Category <b>N</b>	<b>Repair Guidance</b>	Ref. No. R021/09	Page 1 of 2
Coverage <input type="checkbox"/> Distributor only <input checked="" type="checkbox"/> Please inform your dealers		Date Issued March 13 <sup>th</sup> , 2009	
Please convey this information to your <input type="checkbox"/> Director <input checked="" type="checkbox"/> General Manager <input checked="" type="checkbox"/> Warranty Dept. <input checked="" type="checkbox"/> Parts Dept. <input checked="" type="checkbox"/> Training Dept. <input checked="" type="checkbox"/> Field Rep.		Date Revised	
Applicable Model  RX-8 (FE/SE)		Applicable Countries or Specifications  Worldwide

## Subject: Chattering Noise from Steering Wheel When Driving on a Rough Road

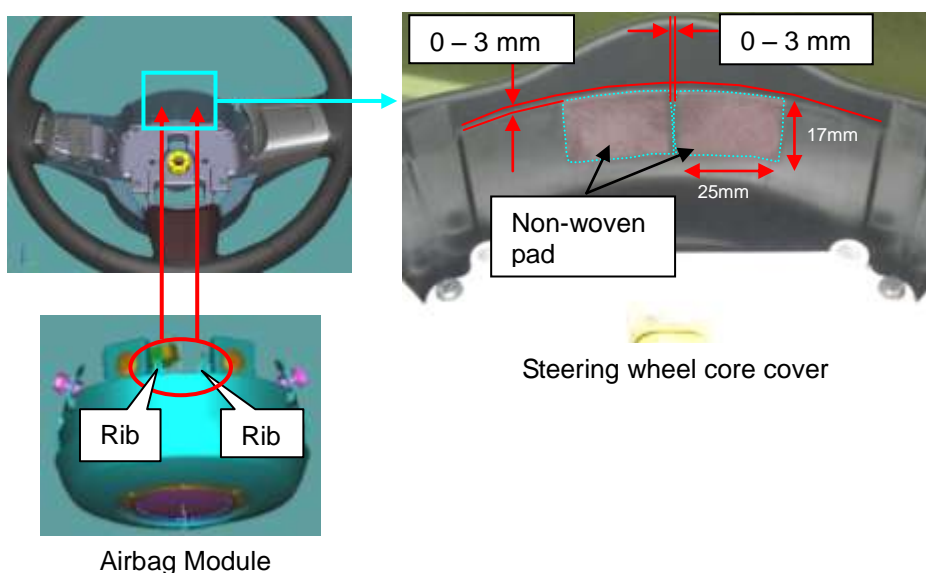
Steering wheel core cover and rib of airbag module contact each other while driving.

Non-woven pad is applied on steering wheel core cover.

1. Remove the driver side airbag module as per Workshop Manual.
2. Apply 2 pieces of non-woven pad on steering wheel core cover as shown in the following picture.

Non-woven pad dimension: 17mm x 25mm, t=1.0mm
